**Ordinary Council meeting
Separate Attachments 1**

11.2	Private Plan Change 35 Tauriko Business Estate Stage 4 - Adoption and Notification of Decisions	
Attachment 1	IHC Recommendation Report - Appendix 1 - Recommended Changes to PPC 35 - 22 August FINAL.....	4
Attachment 2	IHC Recommendation Report - Appendix 2 - Recommendations on Submissions - 22 August FINAL	41
Attachment 3	IHC Recommendation Report - 22 August 2024 FINAL	48

Appendix 1: Recommended Amendments to Private Plan Change 35 to the Tauranga City Plan, Tauriko Business Estate Stage 4

Appendix 18D: Tauriko Business Estate Mitigation, Landscape Features and Buffer Zones

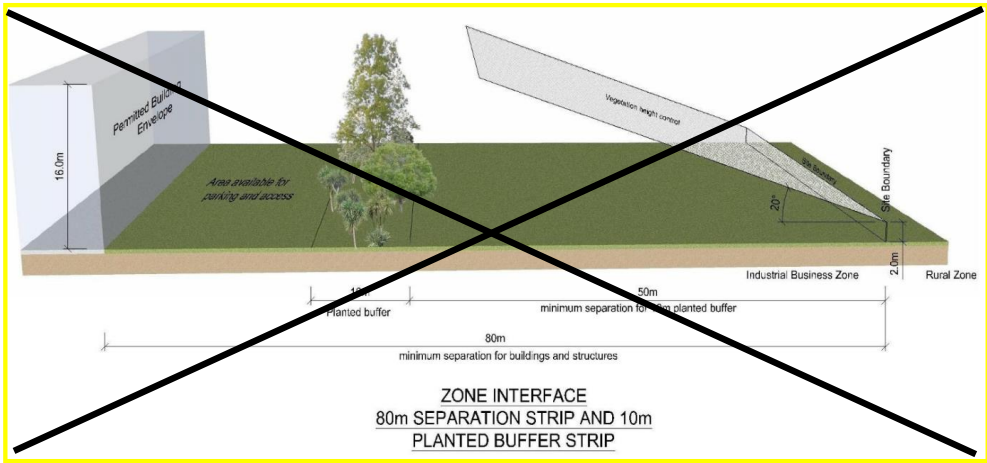
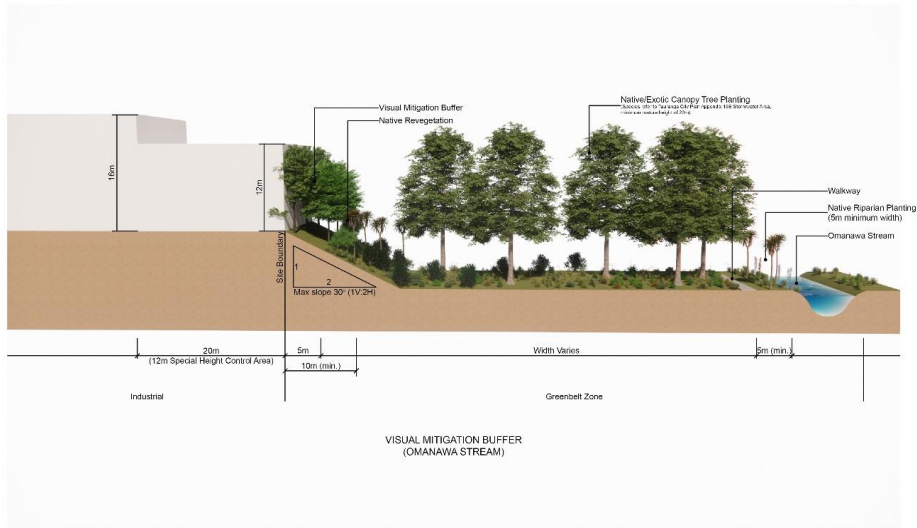
Delete existing diagram and insert replacement diagram into Appendix 18D Tauriko Business Estate Mitigation, Landscape Features and Buffer Zones as follows:

Replacement diagram:

Appendix 18I: Tauriko Business Estate Typical Road Plans and Cross-Sections

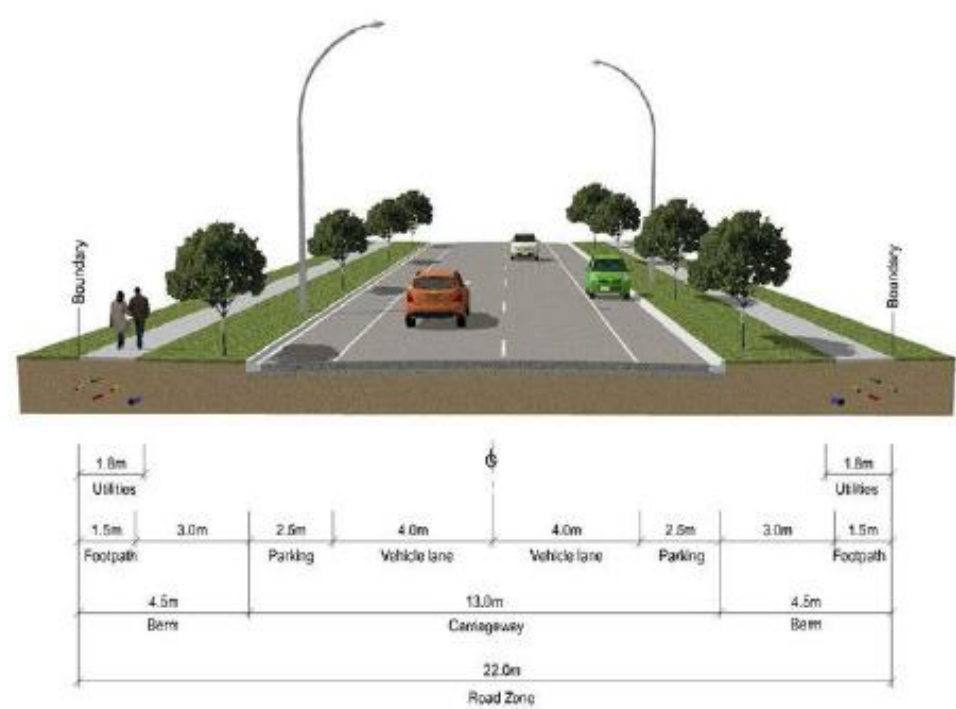
Insert note into Appendix 18I Tauriko Business Estate Typical Road Plans and Cross-Sections as follows:

Note: These cross-sections apply to Stages 1 to 3 (as per *Diagram 9, Section 5 (Part B, Plan Maps) Tauriko Staging Plan*). The development of roads in Stage 4 are subject to the Council's Infrastructure Development Code.

Diagram 2 - SH29/Redwood Lane intersection upgrade and ~~Mitigation Measure at Belk Road closure~~

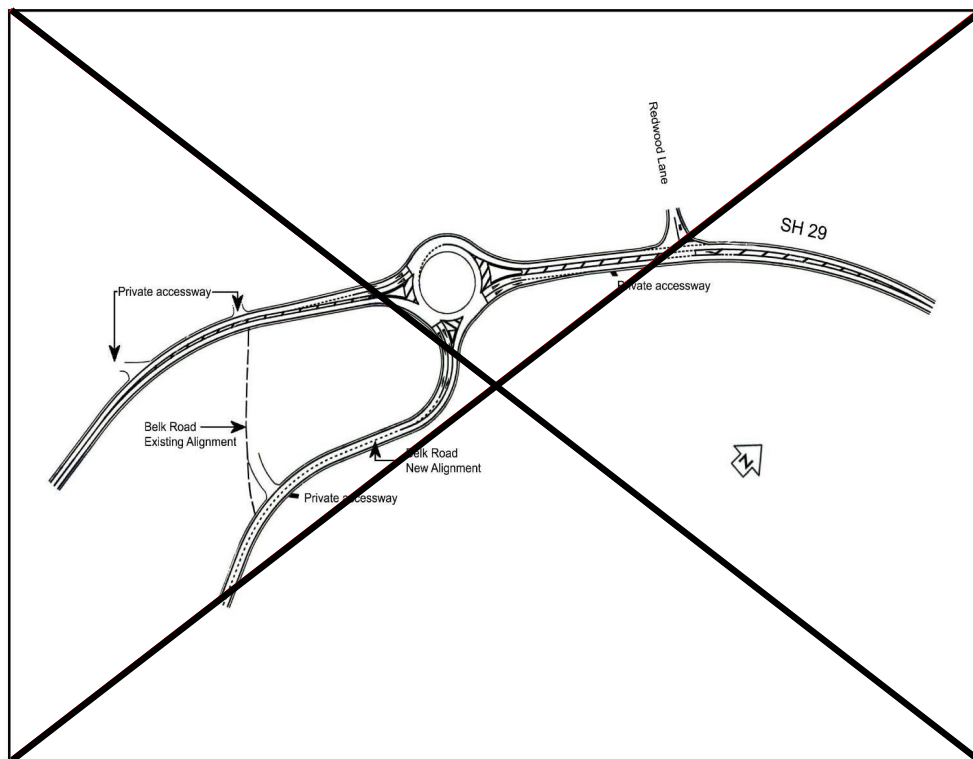
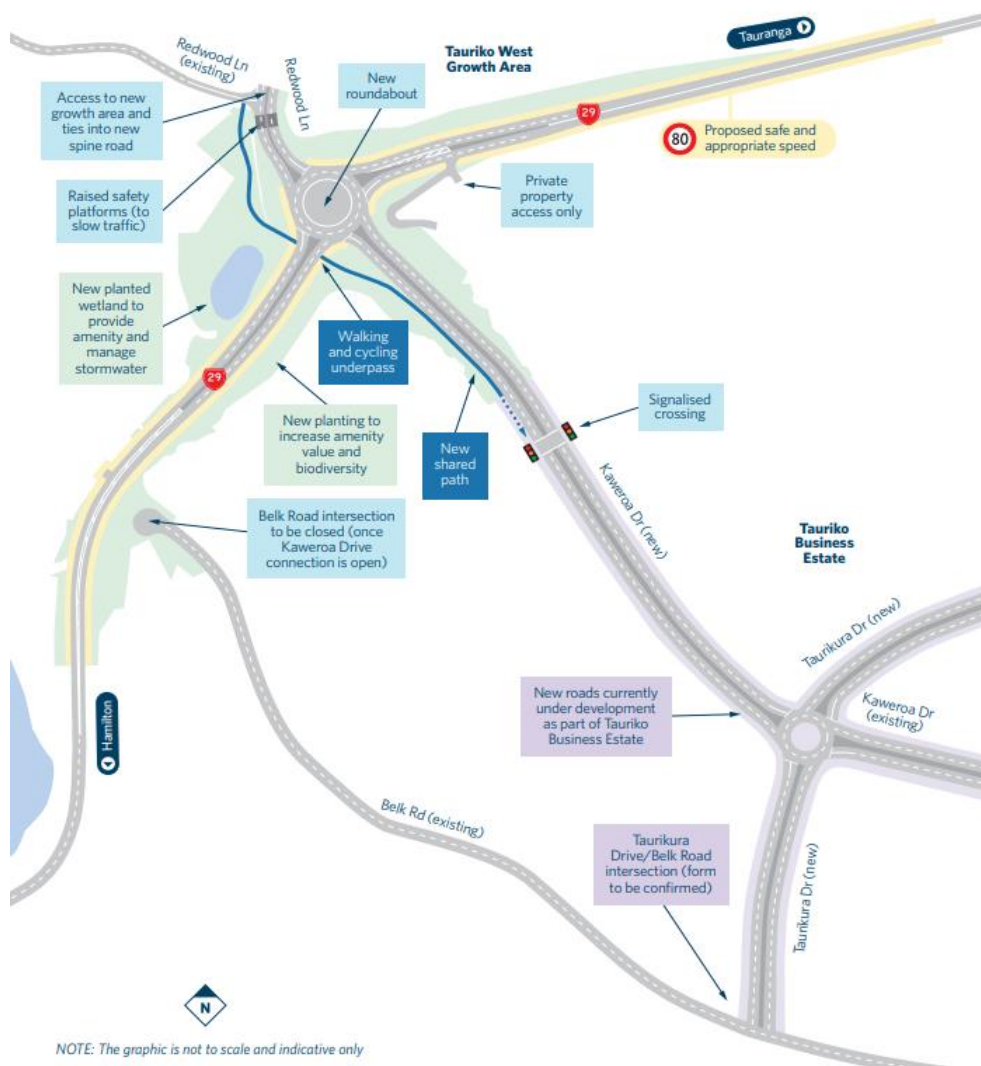
Amend Appendix 18J Tauriko Business Estate – External Roding Mitigation Measures by amending text and replacing Diagram 2 as follows:

Note: Diagram 2 - ~~SH29/Redwood Lane intersection upgrade and Belk Road closure Mitigation Measure at Belk Road~~ is the same as ~~Diagram 11 Proposed Tauriko Business Estate Stage 3 Mitigation Measures~~ Drawing No. Z1040605, Sheet No. G003, Rev. C, MWH, 9/02/2007 the indicative plan included in the Waka Kotahi NZ Transport Agency "Tauriko Enabling Works" package.

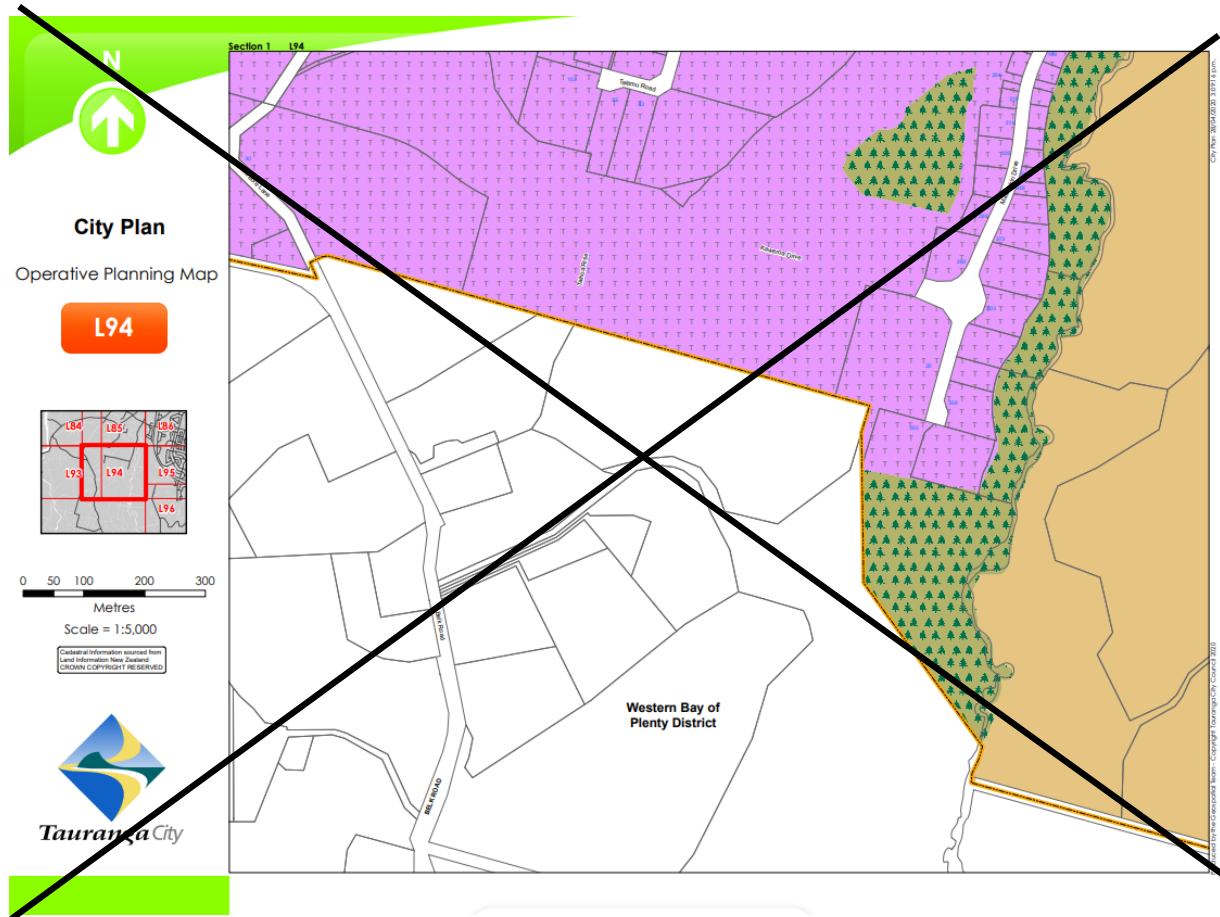
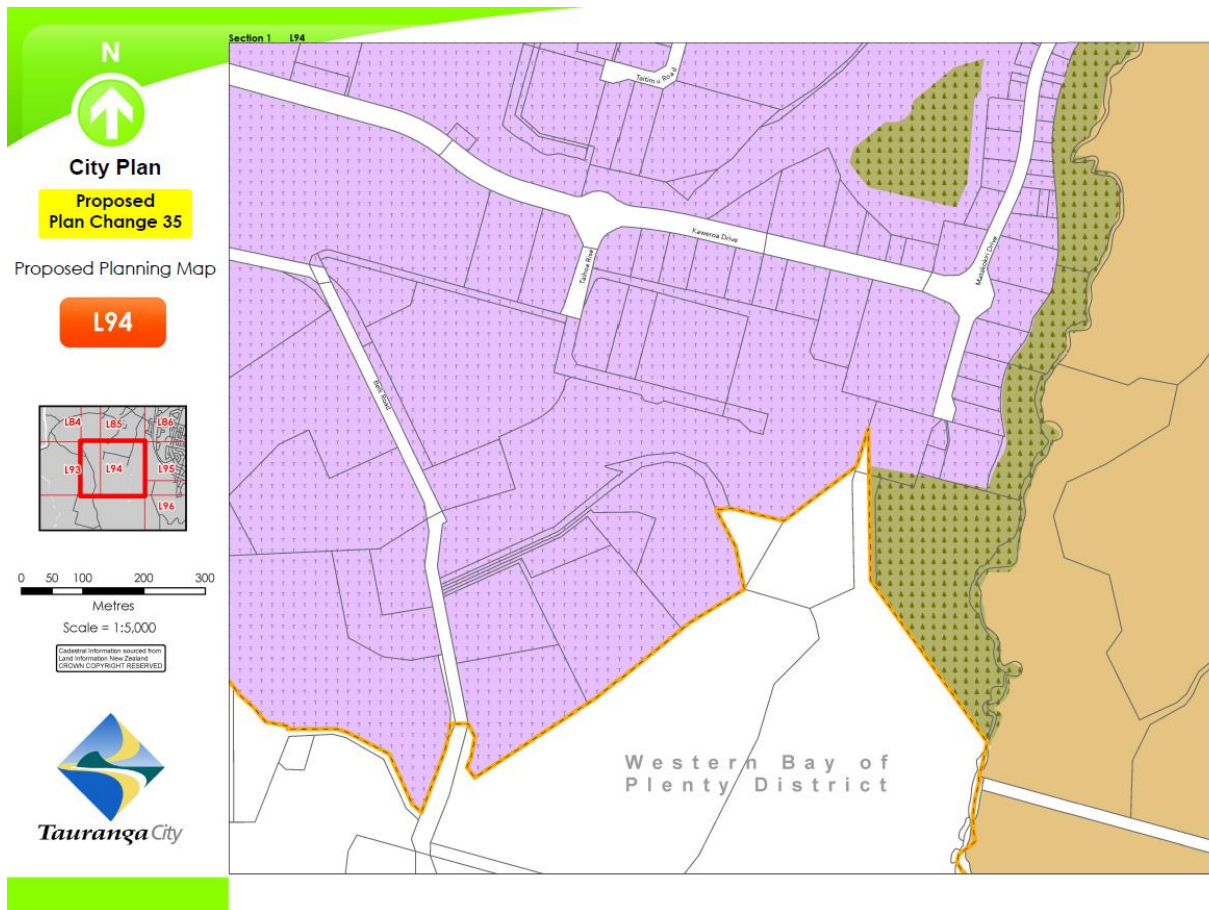
Amend Section 1 Left: Map 93 by replacing Map L93 as follows:

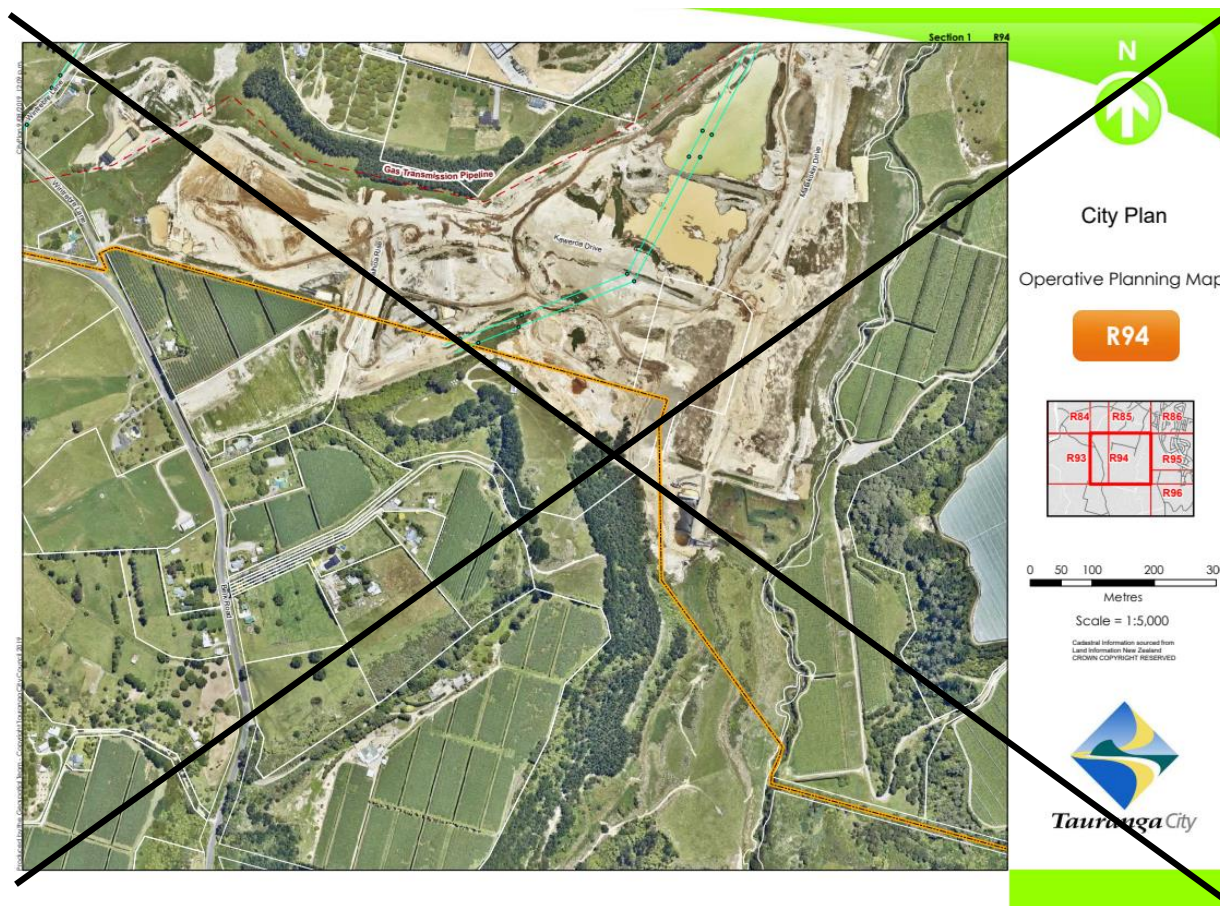
Amend Section 1 Right: Map 93 by replacing Map R93 as follows:

Section 1 R94

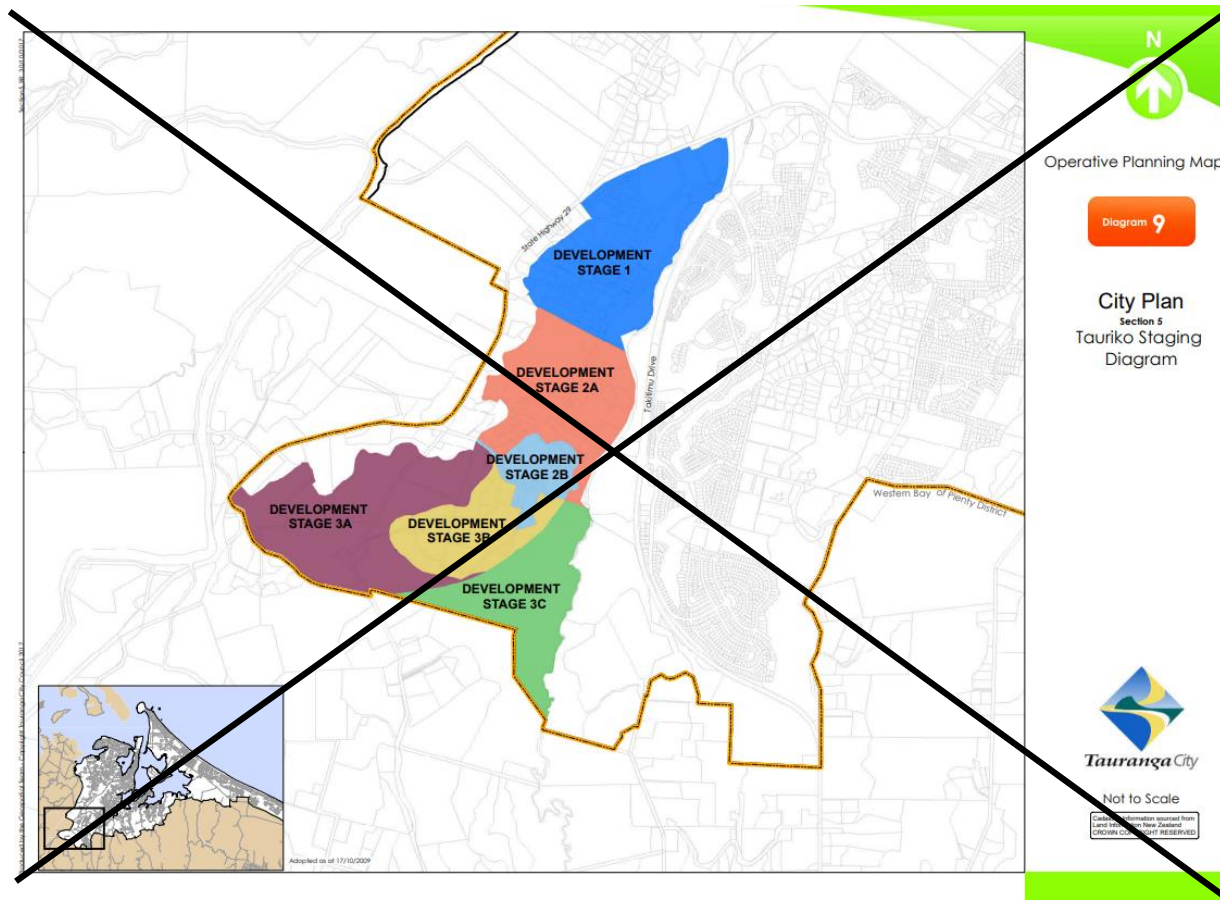
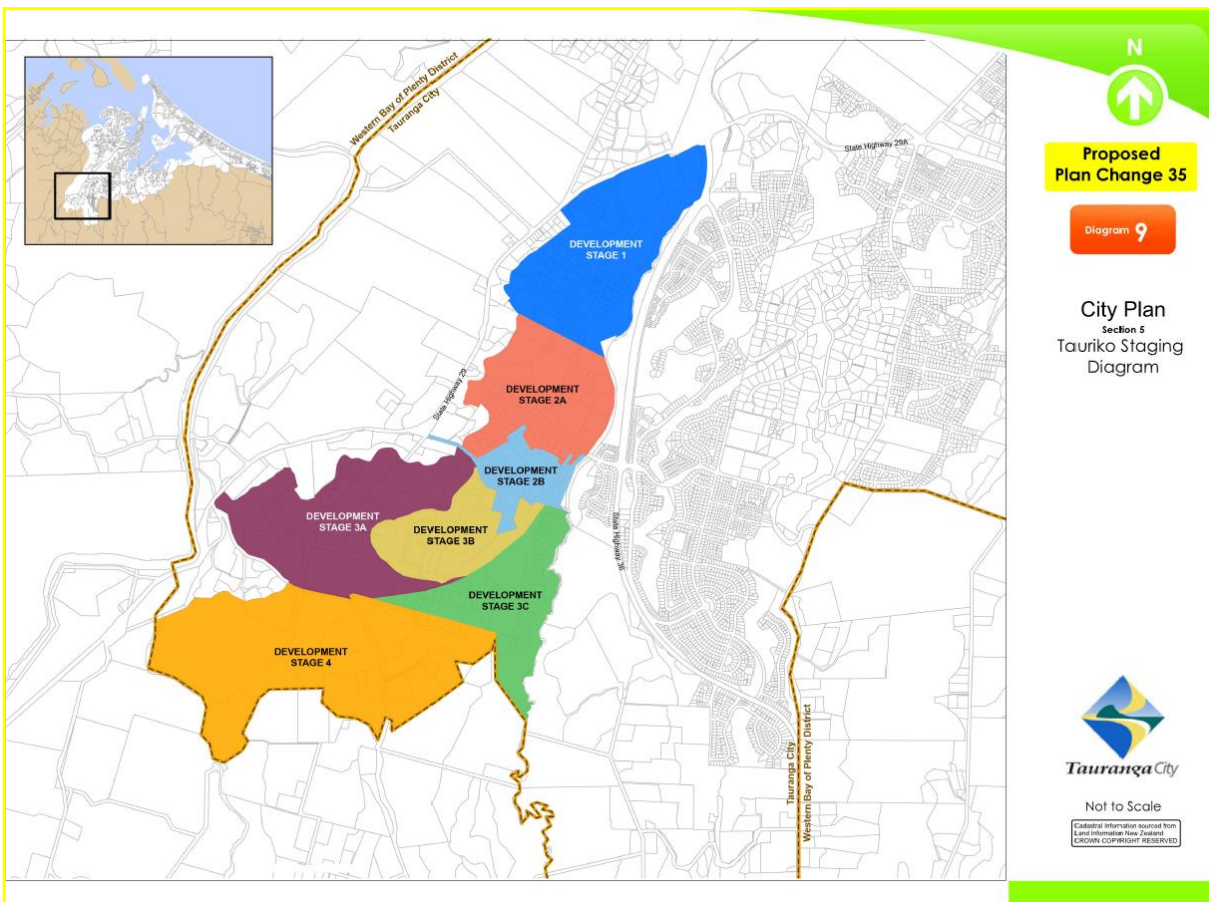
Amend Section 1 Right: Map 94 by replacing Map R94 as follows:

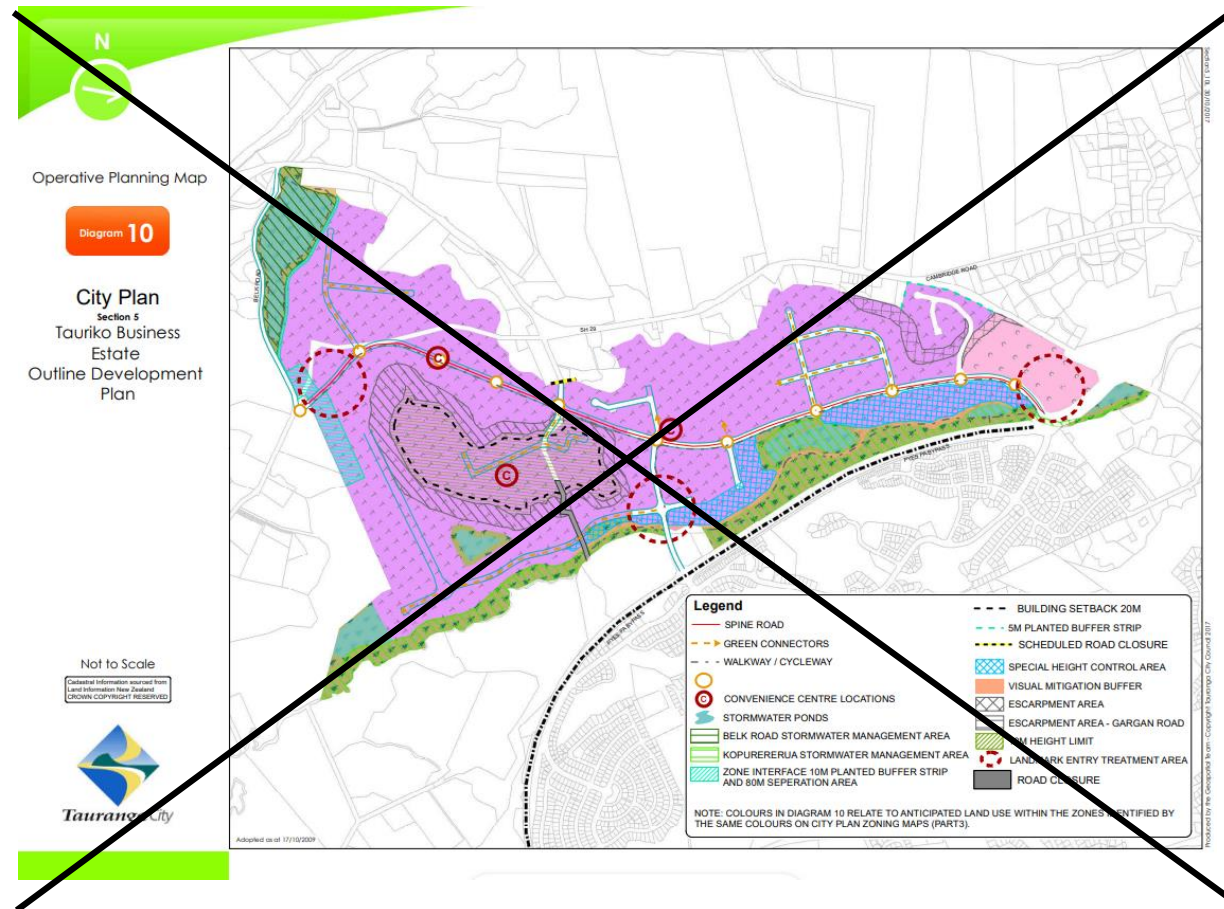
Amend Section 5: Various Diagrams, Diagram 9 Tauriko Staging Diagram by replacing Diagram 9 as follows:

Tauriko Business
Estate Outline
Development Plan

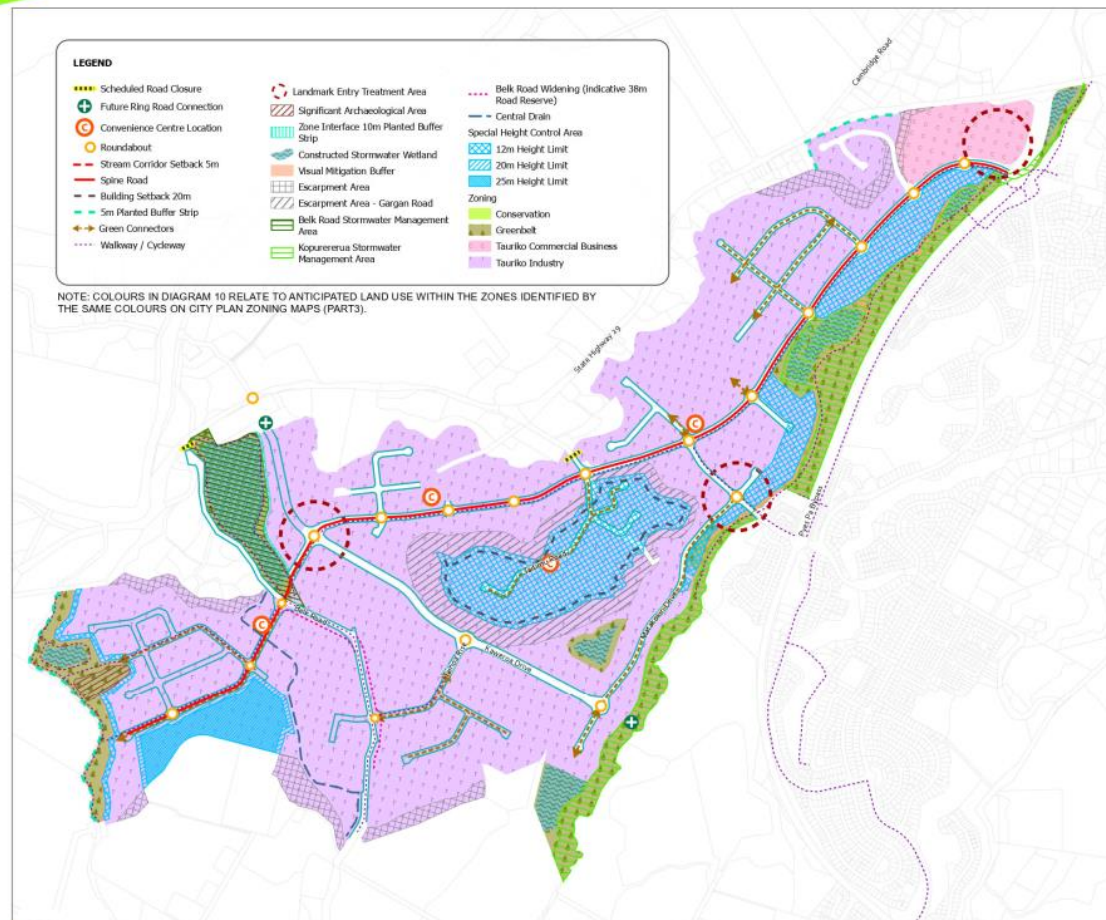
Amend Section 5: Various Diagrams, Diagram 10 Tauriko Business Estate by replacing Diagram 10 as follows (New Image below)
